Plymouth South High School
Plymouth, MA
Ai3 Project # - 1308.00

Addendum #5

June 26, 2015

DRAWN BY:	AJE	SKL-010
SCALE:	N/A	
JOB NO:	1308.00	
DATE:	06/26/2015	
REF DWG:		L33

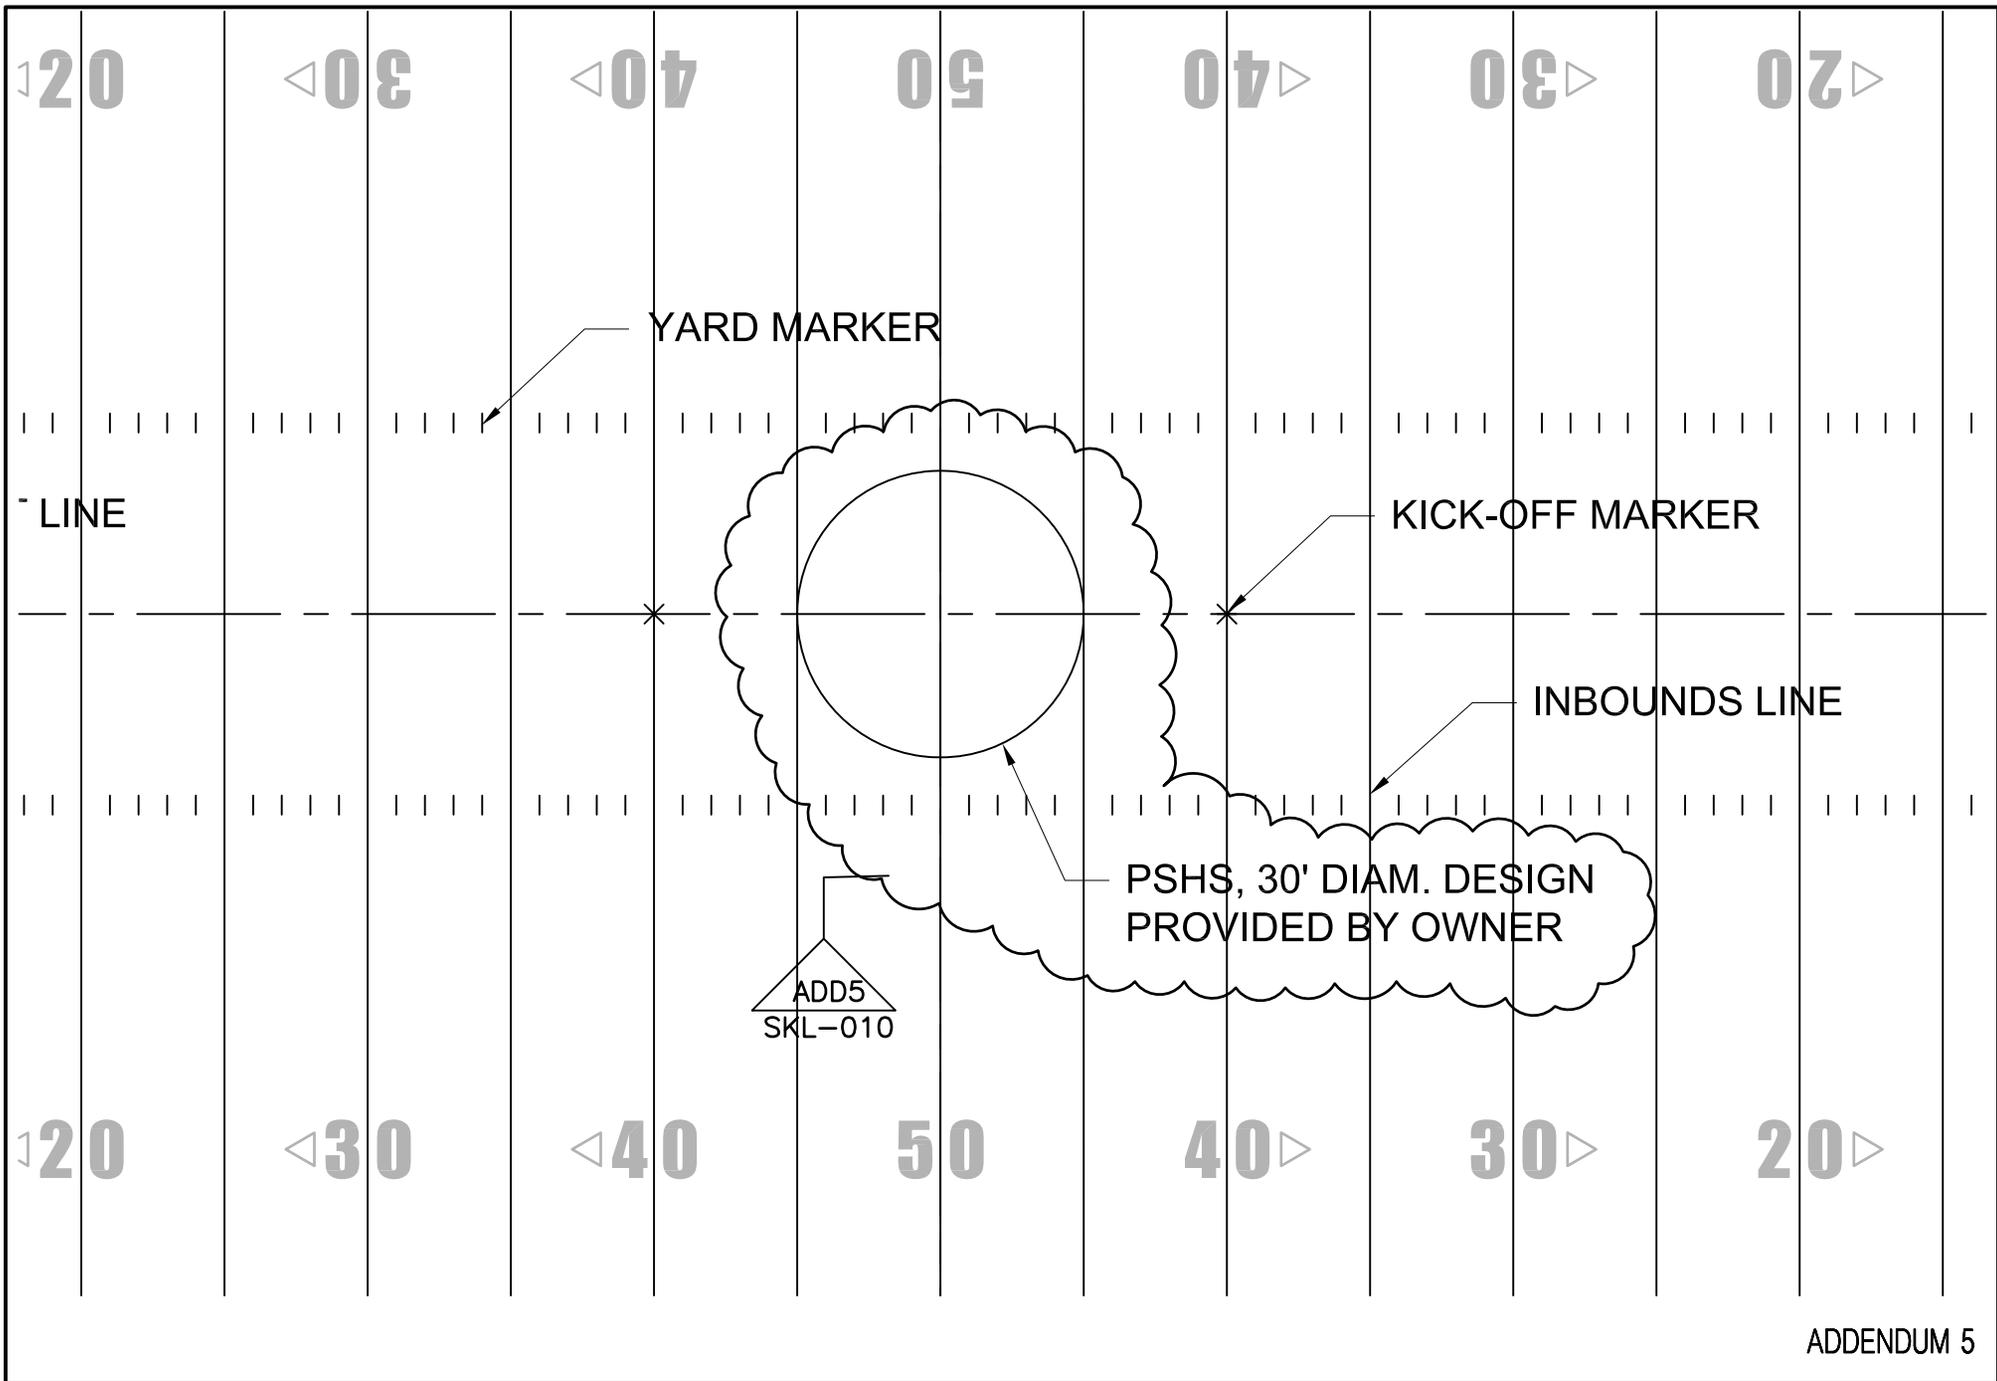
- ADD 5-039 Page 32 92 40-8, Section 32 92 40, SYNTHETIC TURF SYSTEM: MULTI-USE STADIUM (FIELD A), Article 2.7, CLARIFICATION: Only Field A is to receive a logo. The logo shall be 30’ in diameter as indicated on drawing L3.3 and SKL-010.

3 SOFTBALL BACKSTOP
SCALE: 1"=10'

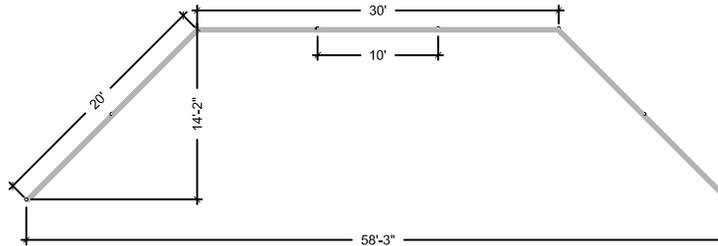
- ADD 5-045 Drawing L3.3 – Landscape Details Plan No. 1
REMOVE "SBRHS" and REPLACE with "PSHS"
- ADD 5-046 Drawing L3.9 – Landscape Details Plan No. 10
Detail 3 / Softball Backstop; REMOVE "4-1/2" x 24' BLACK UPRIGHTS" and REPLACE with "4-1/2" x 20' BLACK UPRIGHTS, SCHED. 40"

- Detail 3 / Softball Backstop; REMOVE "HORIZONTAL BLACK RAIL 1-5/8" X 10' and REPLACE with "HORIZONTAL BLACK RAIL 1-5/8"X10', SCHED. 40".
- Detail 3 / Softball Backstop; REMOVE "CONCRETE FOOTING TO BE STAMPED BY STRUCTURAL ENGINEER" and REPLACE with "CONTRACTOR TO PROVIDE SHOP DRAWING FOR CONCRETE FOOTING TO BE STAMPED BY A STRUCTURAL ENGINEER LICENSED IN THE STATE OF MASSACHUSETTS".

- ADD 5-048 Drawing L3.9 – Landscape Details Plan No. 10
CLARIFICATION: The backstops do not have any canopies
- CLARIFICATION: 4-1/2" uprights at 10' on center are adequate for calculated wind load for softball backstop assuming that the stamped structural engineered foundation shop drawings provided by the contractor are adequate.

4 BASEBALL BACKSTOP
SCALE: 1"=10'

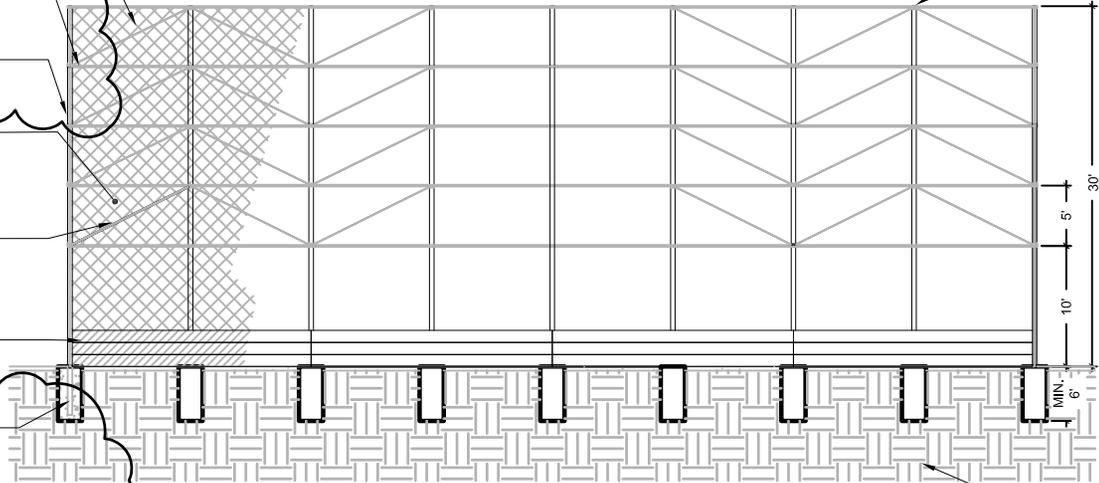
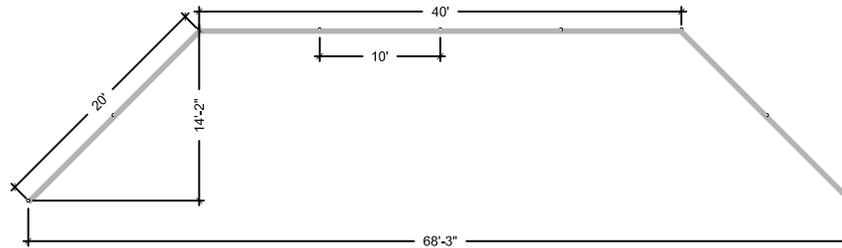
- ADD 5-047 Drawing L3.9 – Landscape Details Plan No. 10
Detail 4 / Baseball Backstop; REMOVE "4-1/2" x 24' BLACK UPRIGHTS" and REPLACE with "4-1/2" x 20' BLACK UPRIGHTS, SCHED. 40"

- Detail 4 / Baseball Backstop; REMOVE "HORIZONTAL BLACK RAIL 1-5/8" X 10' and REPLACE with "HORIZONTAL BLACK RAIL 1-5/8"X10', SCHED. 40".
- Detail 4 / Baseball Backstop; REMOVE "CONCRETE FOOTING TO BE STAMPED BY STRUCTURAL ENGINEER" and REPLACE with "CONTRACTOR TO PROVIDE SHOP DRAWING FOR CONCRETE FOOTING TO BE STAMPED BY A STRUCTURAL ENGINEER LICENSED IN THE STATE OF MASSACHUSETTS".

CLARIFICATION: 4-1/2" uprights at 10' on center are adequate for calculated wind load for baseball backstop assuming that the stamped structural engineered foundation shop drawings provided by the contractor are adequate.
